Subject: VIRGIL C. SUMMER NUCLEAR STATION (VCSNS) UNIT 1
DOCKET NO. 50-395
OPERATING LICENSE NO. NPF-12
LICENSE AMENDMENT REQUEST LAR-14-05497
REQUEST FOR NRC APPROVAL OF RADIATION EMERGENCY PLAN
CHANGE

**VIRGIL C. SUMMER NUCLEAR STATION (VCSNS) UNIT 1
DOCKET NO. 50-395
OPERATING LICENSE NO. NPF-12**

**Virgil C. Summer Nuclear Station Unit 1
Proposed Radiation Emergency Plan Changes**

**Virgil C. Summer Nuclear Station Unit 1
Proposed Changes to
Licensing Basis Documents (Markup)**

Figure 1-3 10-Mile Emergency Planning Zone (Exposure Pathway)

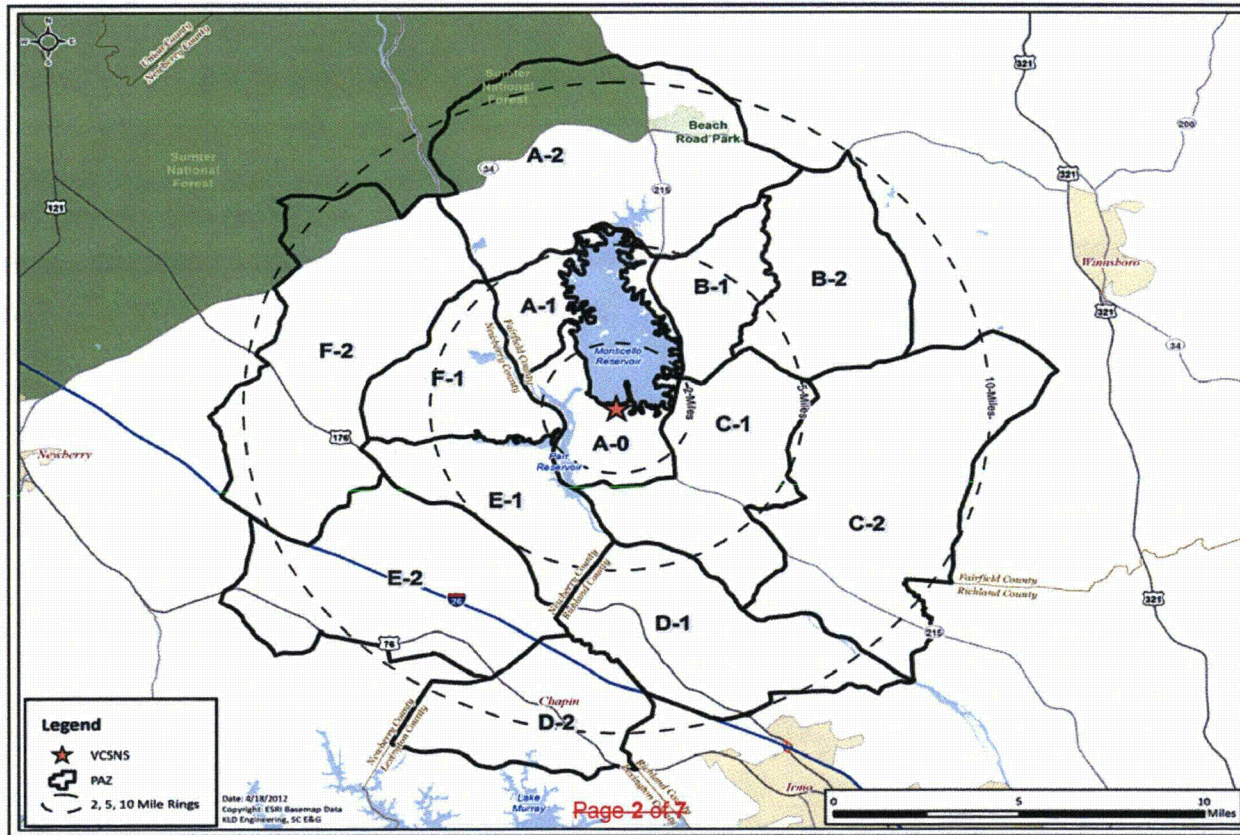
The Plan Part 1, Figure 1-3 (10-Mile Emergency Planning Zone (Exposure Pathway)) is being replaced in its entirety with a new Figure 1-3 which includes the expanded area in Lexington County (PAZ D-2).

The plume exposure Emergency Planning Zone (EPZ) for the VCSNS is an area surrounding the VCSNS site with Unit 1 at the center and having a radius of about ten (10) miles, including an expanded area in Lexington County south and west of Chapin, SC. The EPZ is divided into Protective Action Zones (PAZ), whose boundaries are described in the VCS Evacuation Time Estimate. (Exact boundaries are determined in concurrence with state and county authorities.) Figure 1-3 shows the EPZ and PAZ. Principal exposure sources from the plume exposure pathway are (a) external exposure to gamma and beta radiation from the plume and from deposition materials and (b) exposure of the internal organs to gamma and beta radiation from inhaled radioactive gases and/or radioactive particles. The time of potential exposure can range from hours to days. In accordance with state and county authorities, the same EPZ is used for VCSNS Units 2 and 3. (Exact boundaries are determined in concurrence with state and county authorities.) Figure 1-3 shows the plume exposure EPZ.
